FEDERAL AVIATION AGENCY  
BUREAU OF FLIGHT STANDARDS  
Washington 25, D. C.

CIVIL AIR REGULATIONS DRAFT RELEASE NO. 61-12

SUBJECT: First Federal Aviation Agency Airworthiness Review

**AIRWORTHINESS**

FIG. 3-12(b)  
BASIC LANDING CONDITIONS

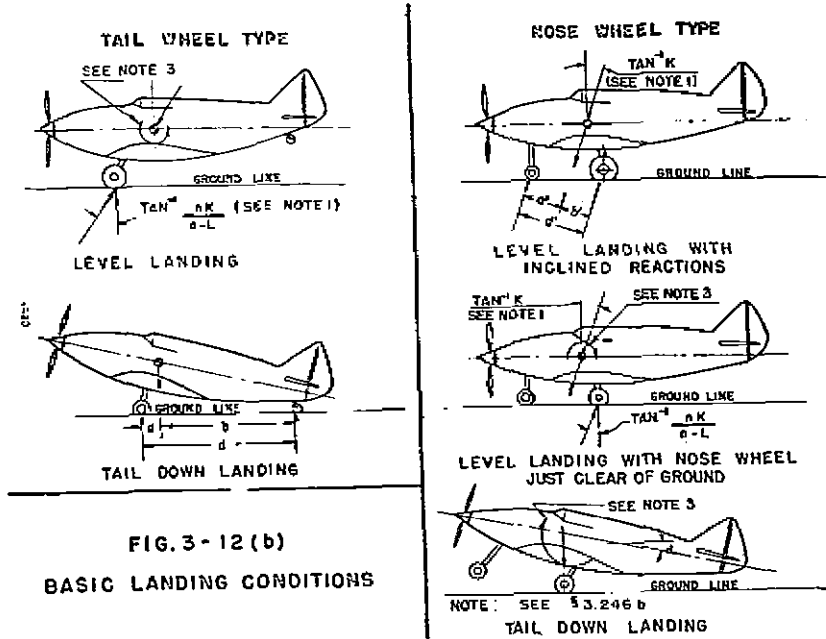
Miscellaneous changes of an editorial or clarifying nature are proposed for §§ 3.1, 3.82, 3.86, 3.216-5, 3.216-6, 3.301, 3.301-1, 3.301-2, 3.573, 3.582, 3.714, 3.744, 3.745, 3.746, 3.747, 3.767, 3.779, 3.780, 3.780-1 and figure 3-12(b).

27. By amending Figure 3-12(b) referred to in § 3.244 as follows:
